Comments and concerns in regard to Application Reference 2014/5463/P, 35 Elsworthy Road, London, NW3 3BT

I write to formally document our concerns in connection with the application for the change of use and works of conversion from 2 flats into single family dwelling house including excavation of basement under footprint of house and rear garden with side and rear lightwells, erection of a 2-storey curved bay to rear to replace existing 1-storey angled bay and demolition of side addition.

drow g	project	1	TU. 330 7336 6335 FAX: GGP 7336 6377 umm oil ordificel@blaporforendbj.co.ok	8B P
Proposed Elevador 4	25 Flownshy Reac London NW3 3PT	Share Seru Attes I Imited c/o iranspera Resources Ltd Lins Poundary Rose London Will BRG		BB PARTNERSHIP LTD

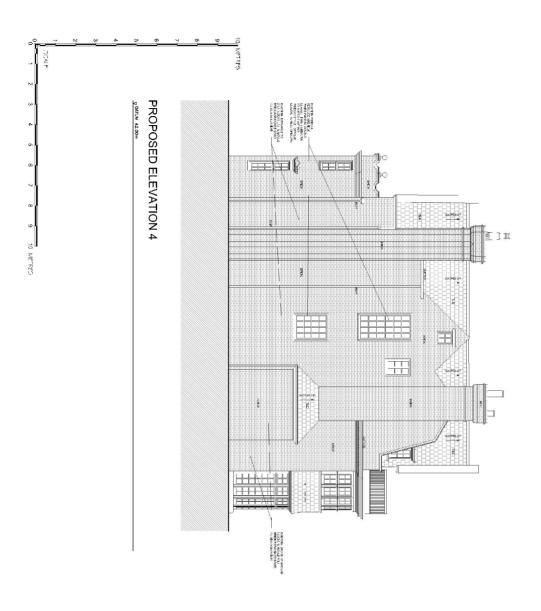
We have concerns over the detailing of the boundary wall between 35/37 and the detailing to the windows on the boundary side (opaque / clear etc).

BB Partnership Limited have confirmed the glazing detail by way of FEV-119.
